# TECHNICAL BULLETIN

**MODEL/DERIVATIVE:**  
**Discovery Series II (LT)**

**Bulletin N°:** 0015  
**CDS. ref:** L8895bu  
**Issue:** 2  
**Date:** 27.01.04

**RADIATOR TOP COOLANT HOSE - LEAKING**  
**ACE high-pressure hose chafing radiator top coolant hose.**

**1**

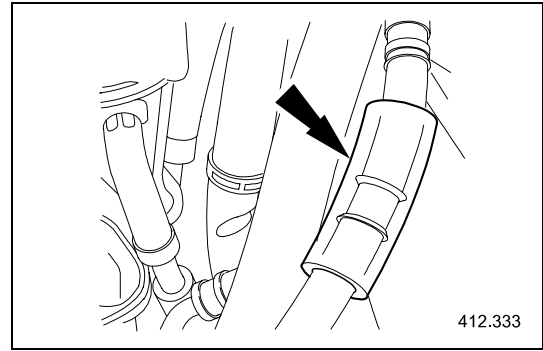
The route taken by either hose is variable, resulting in a possible foul condition. The foam protector that covers the ACE hose crimp can wear through, allowing the crimp to contact the top coolant hose. This can result in abrasion damage to the coolant hose.

5. If installed, remove the foam protector from the ACE high pressure hose, and discard (see illustration 1).

**2**

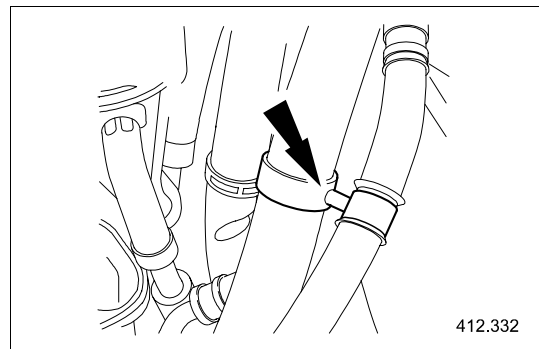
6. If the radiator top coolant hose has abrasion damage, drain the cooling system. Refer to Workshop Manual, part number VDR100090 (8<sup>th</sup> Edition), Engine Td5 - Cooling System Td5 - Adjustments - drain and refill, repair number 26.10.01.
7. Release and reposition both the radiator top coolant hose securing clips.
8. Remove the radiator top coolant hose from the vehicle remove securing clips and discard the radiator top coolant hose.
9. Install hose securing clips to the new radiator top coolant hose.
10. Install the new radiator top coolant hose to the vehicle; reposition the radiator top coolant hose securing clips.
11. Install the new hose clip spacer (see illustration 2).

*Note: Ensure the radiator top coolant hose and the ACE high-pressure hoses are separated.*
